Access Compliance Report

Public Rights-of-Way

Intersection ID: 21076	Main Street: WESTINGHOUSE_BV	Cross Street: WITHERS_COVE_PARK_DR	Location: SE
ADA ID: 520AA047A88A	Ramp Type: PerpDiag	Initial Pass/Fail: Fail	Overall Compliance: No
		Severity Score: 10

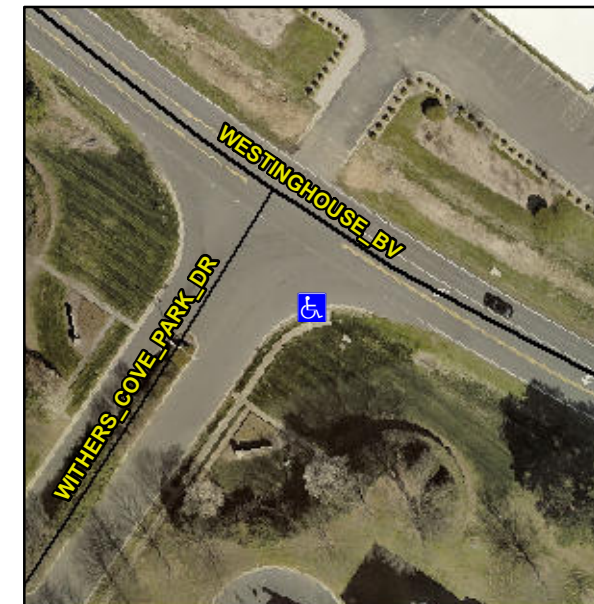
R304.5.1, R304.5.3

Compliance	Description	Data	Compliance	Description	Data
N/A	Ramp Length (in)	51.0	Yes	Ramp Slope (%)	7.7
No	Ramp Width (in)	46.0	No	Ramp XSlope (%)	2.1
N/A	Flare Type LT	N/A	N/A	Flare Type RT	N/A
N/A	Flare Slope LT (%)	N/A	N/A	Flare Slope RT (%)	N/A
N/A	Flare Traversable LT?	N/A	N/A	Flare Traversable RT?	N/A
N/A	Landing Length (in)	N/A	N/A	DWS Provided?	N/A
N/A	Landing Width (in)	N/A	N/A	DWS Contrast?	N/A
N/A	Landing Slope (%)	N/A	N/A	DWS Length (in)	N/A
N/A	Landing X Slope (%)	N/A	N/A	DWS Full Width?	N/A
N/A	Landing Curb? (Y/N)	N/A	N/A	DWS Offset (in)	N/A
N/A	Shared Landing?	N/A			
N/A	Gutter Ponding?	N/A	N/A	Gutter Slope (%)	N/A
N/A	Gutter Lip Ht (in)	N/A	N/A	Gutter X Slope (%)	N/A
N/A	Painted X Walk1?	No	N/A	Painted X Walk2?	No
	X Walk 1 Direction	To NE		X Walk 2 Direction	To NW
N/A	X Walk 1 Width (in)	N/A	N/A	X Walk 2 Width (in)	N/A
	X Walk 1 Slope (%)	1.2		X Walk 2 Slope (%)	0.6
	X Walk 1 X Slope (%)	0.5		X Walk 2 X Slope (%)	0.5

Remove & Replace Curb Ramp With Two New Directional Ramps or Equivalent.
